Subject: VIBRATION FELT THROUGH FLOOR / SEAT / STEERING WHEEL AT APPROX. 25 - 30 MPH	Bulletin No: 03-001/17
	Last Issued: 01/09/2017

This bulletin supersedes the previously issued bulletin(s) listed below: The changes are noted in Red beside the change bars.

Previously issued TSBs:	Date issued:
03-003/16	08/11/2016

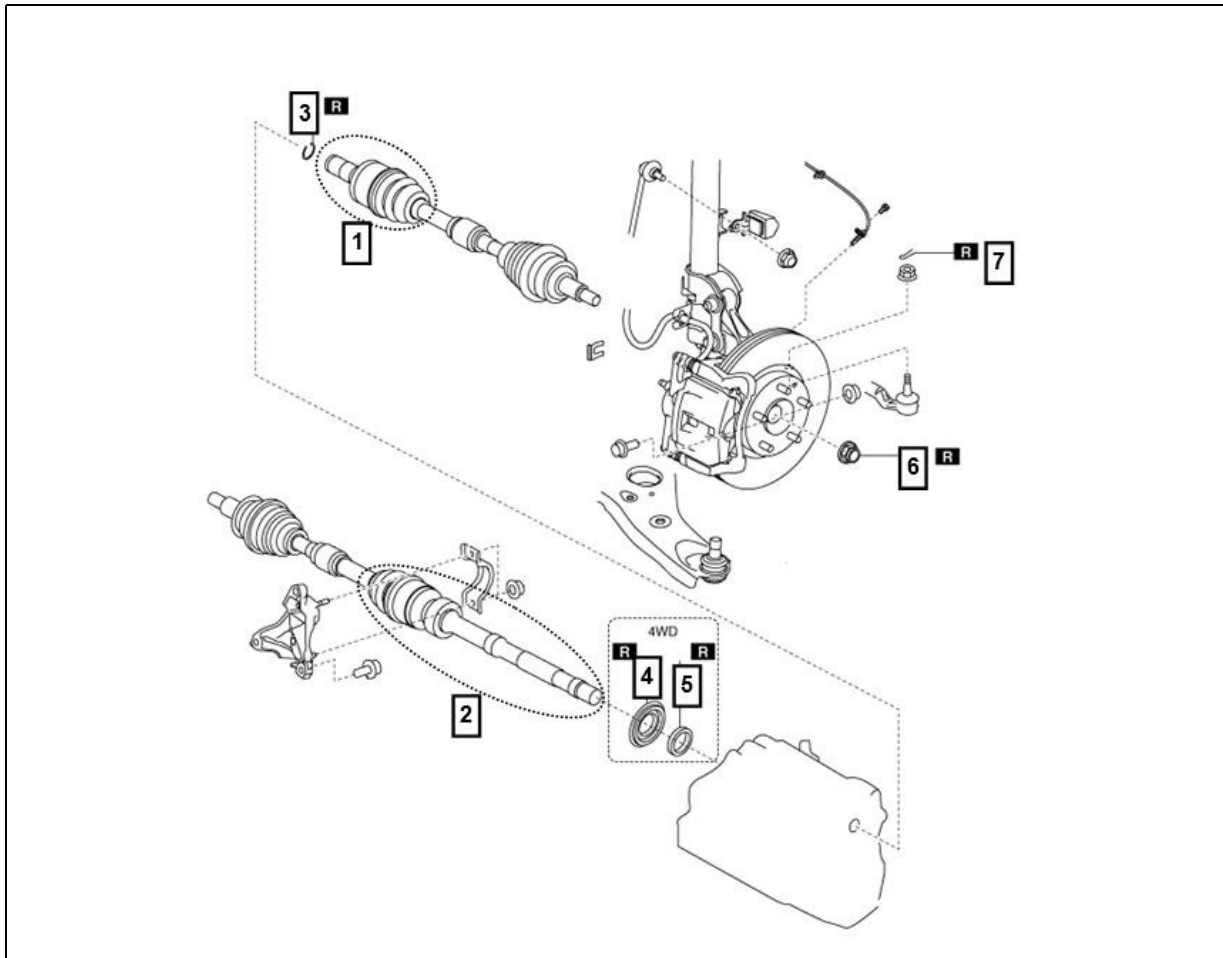
The vibration may be caused by wear on the inner surface of the tripod joint case (inner side of front drive shaft). To eliminate this concern, a coating has been applied to the inner surface of the tripod joint case to improve wear resistance.

1. Verify the customer concern.
2. Replace the inner joint set for the left and right drive shafts. Refer to MS3 online Workshop Manual:
 - CX-5 - FRONT DRIVE SHAFT REMOVAL/INSTALLATION and FRONT DRIVE SHAFT (TRIPOD JOINT) DISASSEMBLY/ASSEMBLY.
 - Mazda6 - FRONT DRIVE SHAFT REMOVAL/INSTALLATION and FRONT DRIVE SHAFT (TRIPOD JOINT) DISASSEMBLY/ASSEMBLY.
3. Verify the repair.
